ADDENDA TO THE NCX-5 MK II

MANUAL AND SCHEMATIC

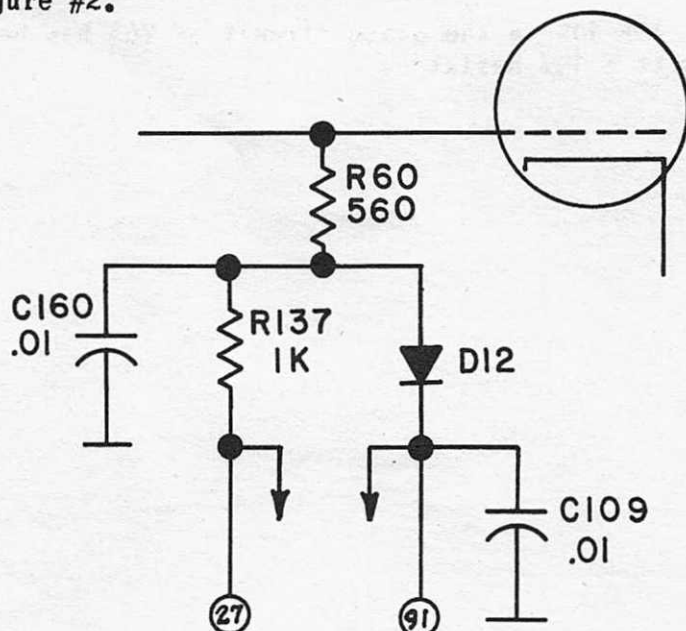
- A. The following changes affect the schematic only. These changes have been incorporated in all NCX-5 MK II transceivers, but not recorded on the schematic.
1. Trimmer C8, was shown incorrectly between pin 9 of V4A and ground. It should be shown between pin 7 (plate) of V4A and ground as seen in figure #1.
 2. Resistor R74, $47K \pm 10\%$ 1/2 watt between pin 9 of V4A and ground should be shown as a $4.7K \pm 10\%$ 1/2 watt resistor.

FIGURE 3

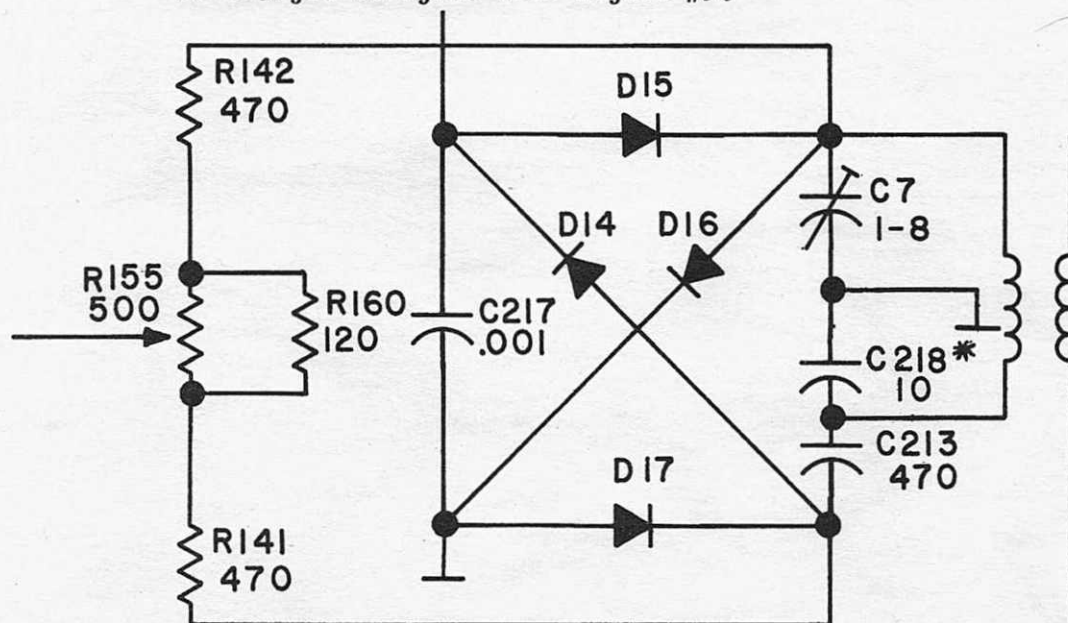
13. Resistor R150, 6.8K in the plate circuit of V10 has been omitted and should be removed from the schematic.
14. The Carrier Balance circuit has been changed. The schematic should be changed to agree with figure #3.
